**Flood Control Project Maintenance
Levee Inspections**

Maintenance Issue Types Only, Levee Inspection Report By Mile - Fall 2024

Reclamation District No. 0554 Walnut Grove

Waterway	Bank	Unit Miles	Inspection Start/End	Inspector
Unit No. 01 Sacramento River	Left	1.13	10/22/2024 10/22/2024	Gregg McMillon

USACE 2018 Erosion Photo #1

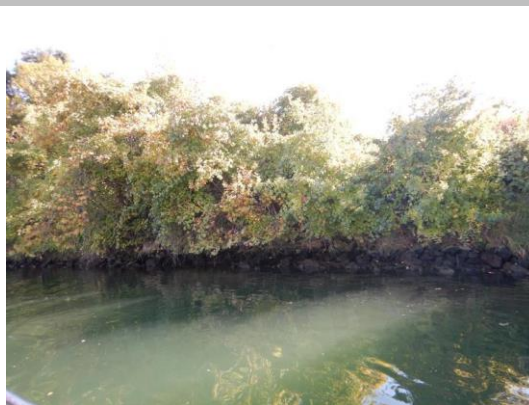
LM Start	0.26	Rating **	M	Issue No.	24
LM End	0.36	Issue Type +	Ma	Location *	WS
Category	Supplemental			GPS Latitude/Longitude	
				Start	End
Item	2018 USACE Erosion Survey			38.246222°	38.245017°
				-121.510878°	-121.511740°
DWR ID	DWR_RD0554_01_s _ 2022_24				
Comment Code					
Inspector Comment					
2018 Site ID: SAC 27.0 L					
Status: Eroding					
2018 Field Notes: No observed change.					
Site History: 2009 - Tension cracks on road on top of levee. Erosion into the levee slope and mass failure. 2013 - Short vertical sections at bank toe. 2017 - Minor new erosion at toe.

Photo 1 of 1 : FA_2024_RD0554_176_46_20241001_00014.jpg

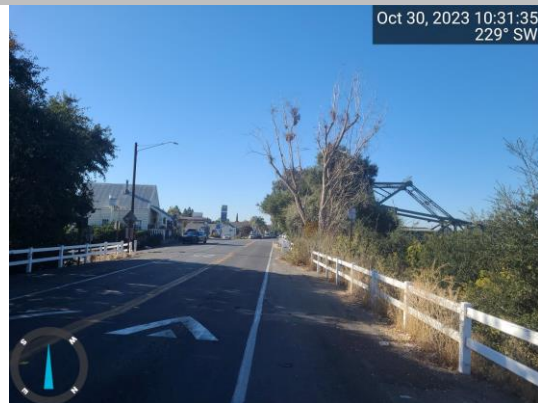
LM Start	0.59	Rating **	M	Issue No.	46
LM End	0.59	Issue Type +	Ma	Location *	WS
Category	Earthen Levee			GPS Latitude/Longitude	
				Start	End
Item	Trim / Thin Trees			38.242125°	38.242125°
				-121.514080°	-121.514080°
DWR ID	DWR_RD0554_01_f_2019_46				
Comment Code					
T1 : Trim and thin trees to at least five feet above ground level to allow visibility of the ground and room to flood fight.					
Inspector Comment					
Low hanging trees on the waterside slope need to be trimmed up at least 5 feet for visibility.
